ADDENDUM NO. 1

DATE: December 5, 2017
FROM: City of Grand Junction Purchasing Division
TO: All Offerors
RE: Professional Engineering Services for Parks Raw Water Irrigation Supply Phase I

**Parks Raw Water Irrigation Supply Phase I
Hwy 50 River Crossing**

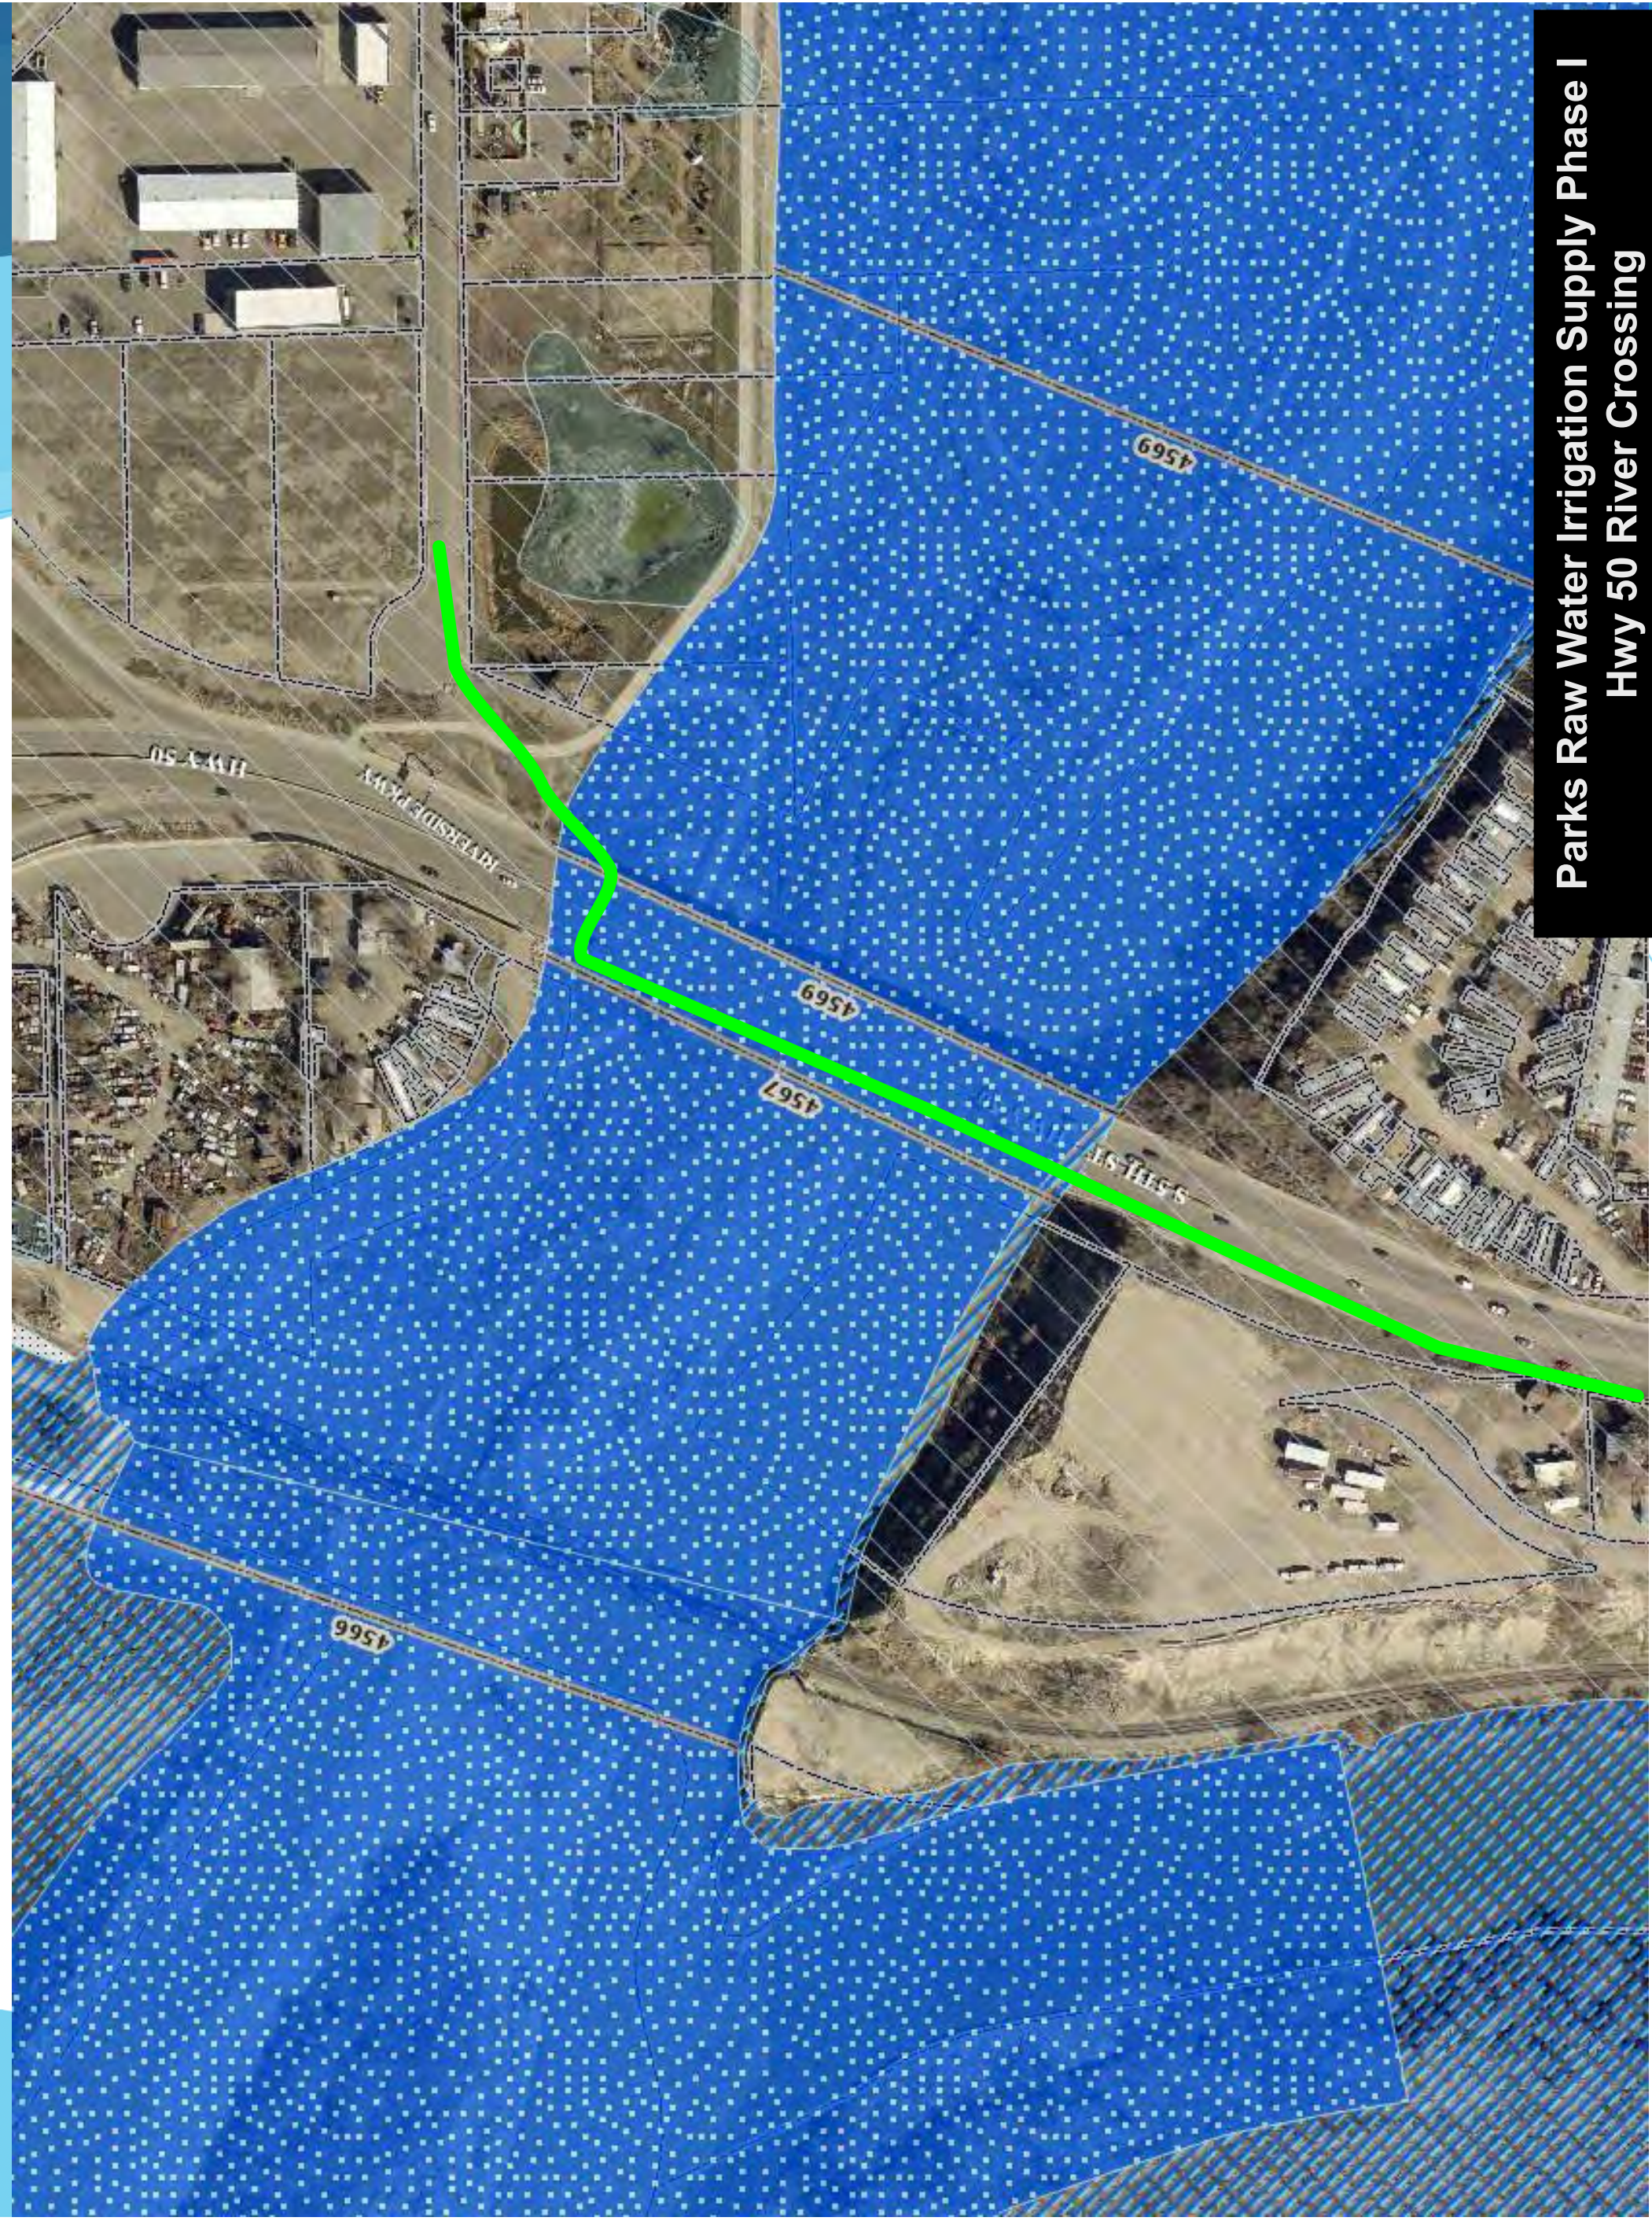
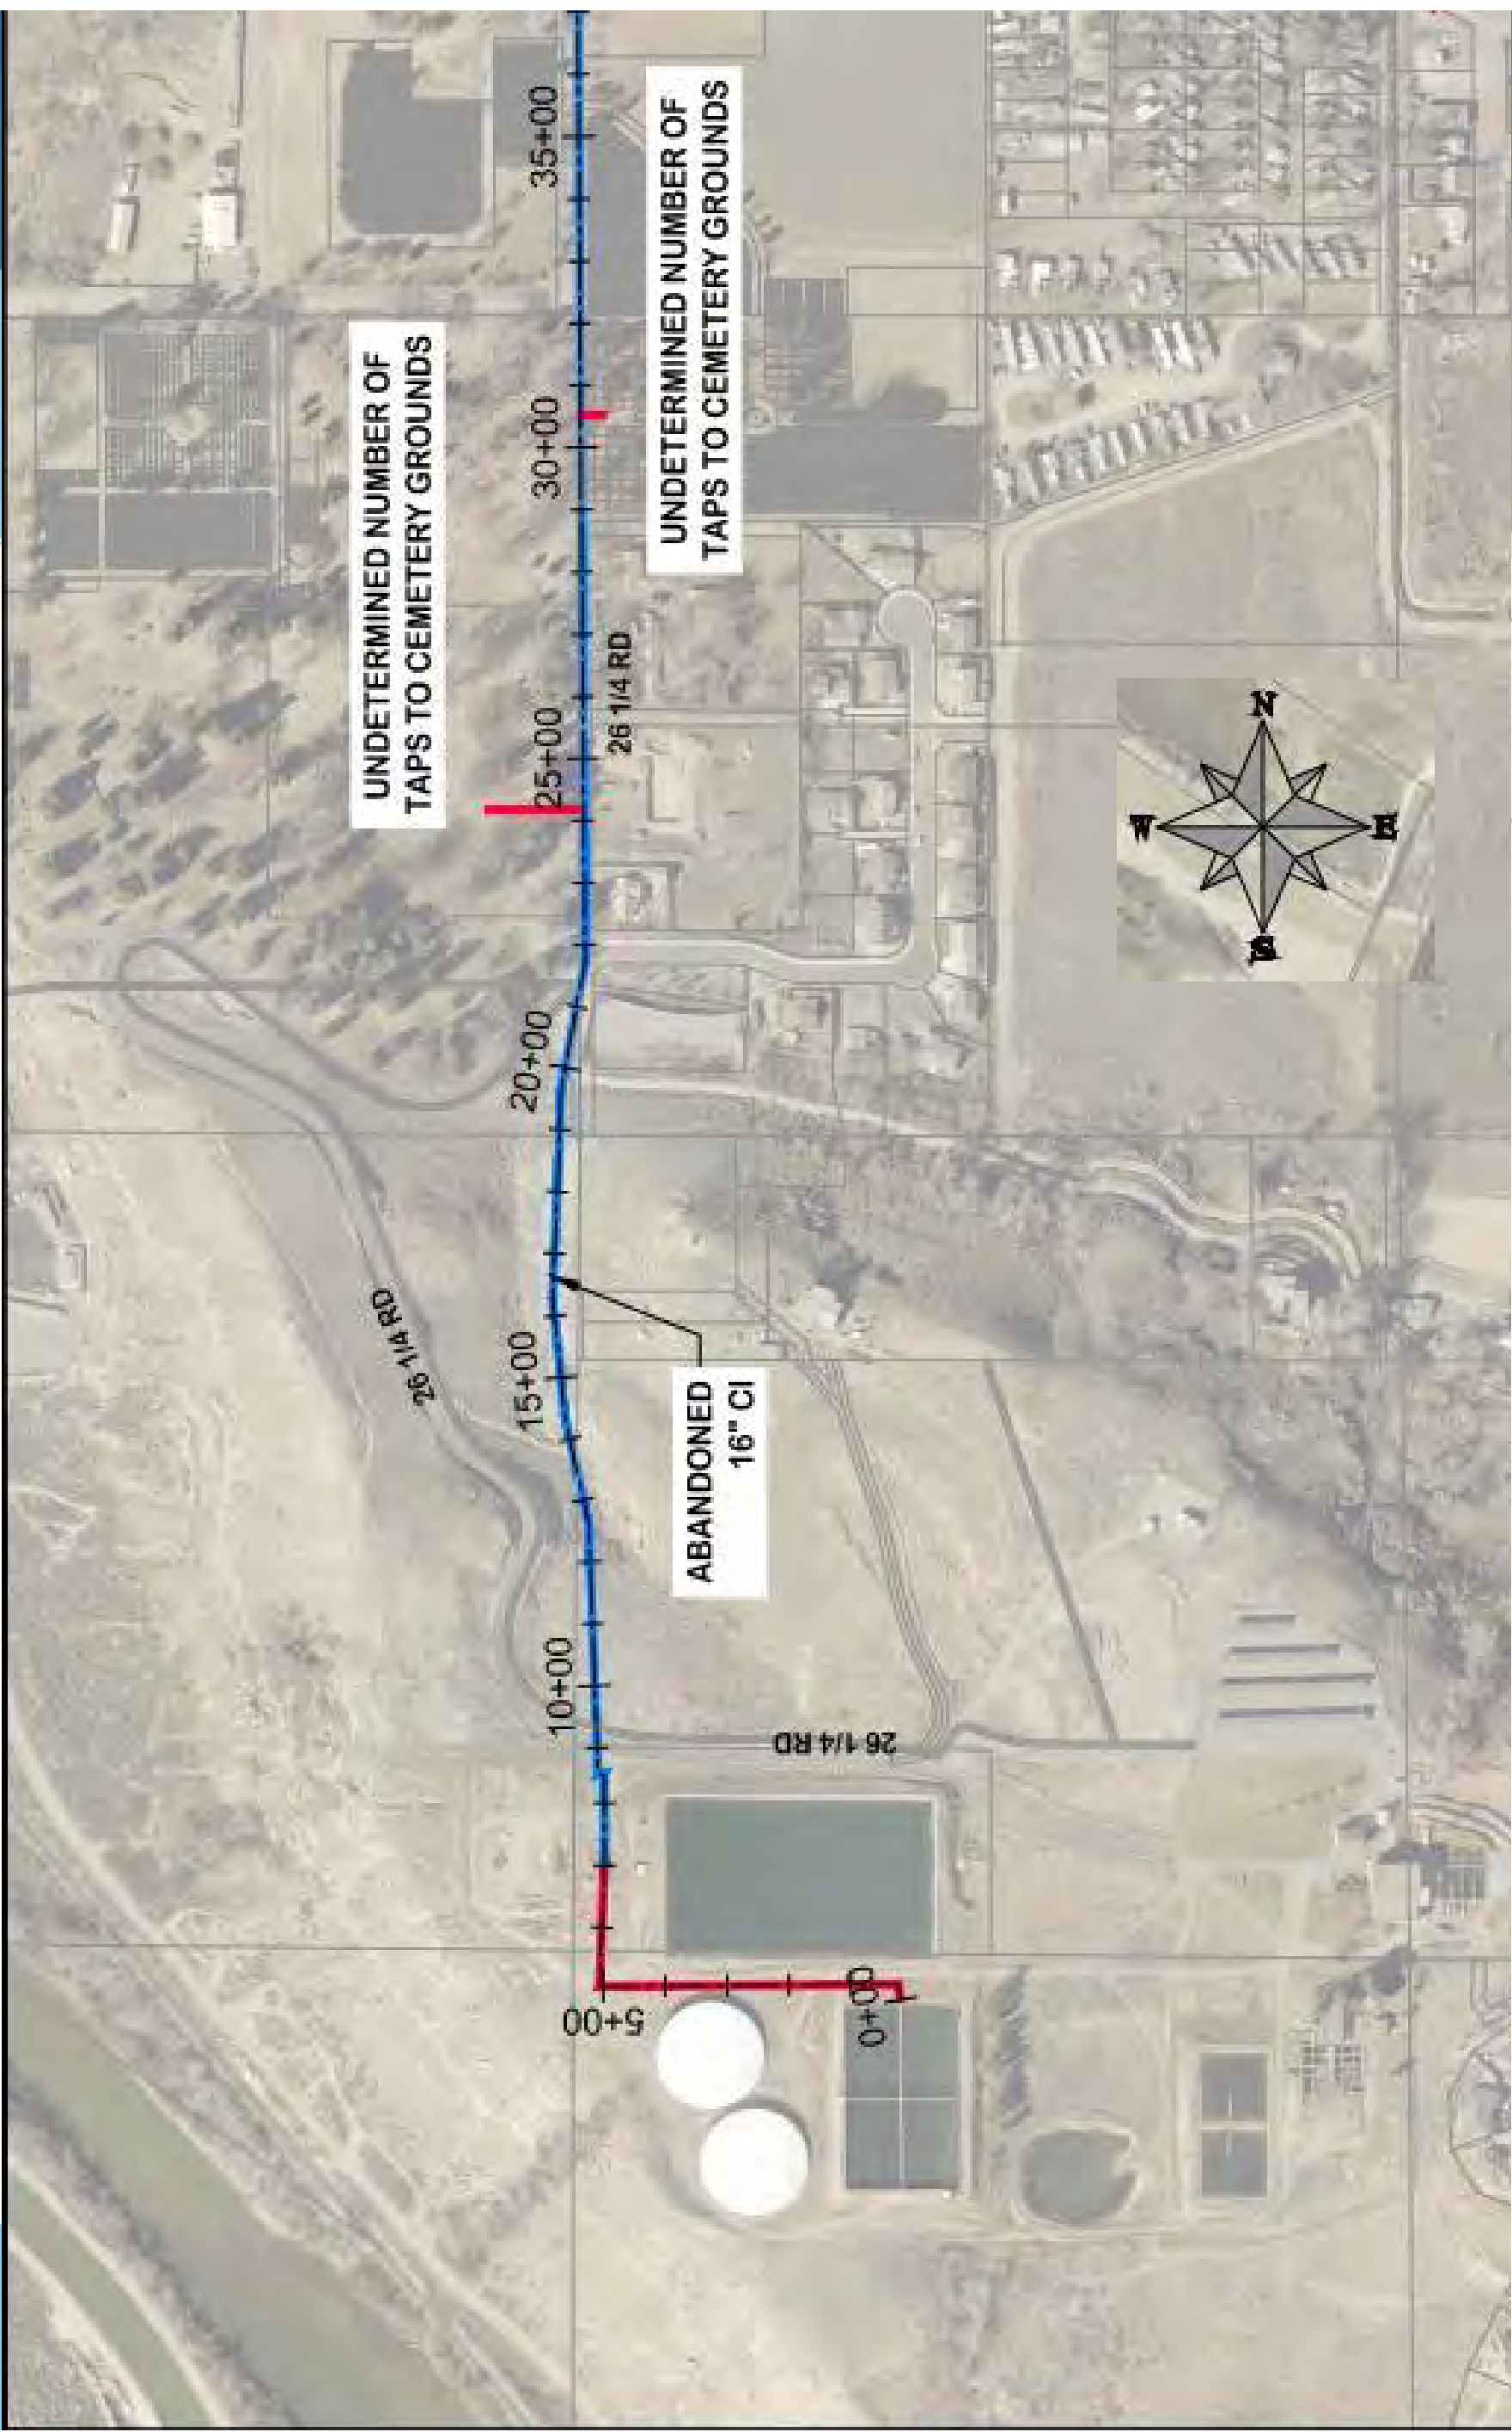
- a. <http://dtdapps.coloradodot.info/bridges/H-02-CA/photos.htm>
- b. <http://dtdapps.coloradodot.info/bridges/H-02-DZ/photos.htm>
11. Q. Is CDOT totally set on leaving the line run down the west side of the bridge?

12. Q. Can the line run on the outside of the west girder?
- A. CDOT current practice is not to allow utilities on the outside girders of bridges and in this case a gas line is already present.

- A. CDOT would be flexible to other alternatives. The west side was selected due to the inside bay of the east side was already occupied. Utilization of the first bay allows for top down construction.
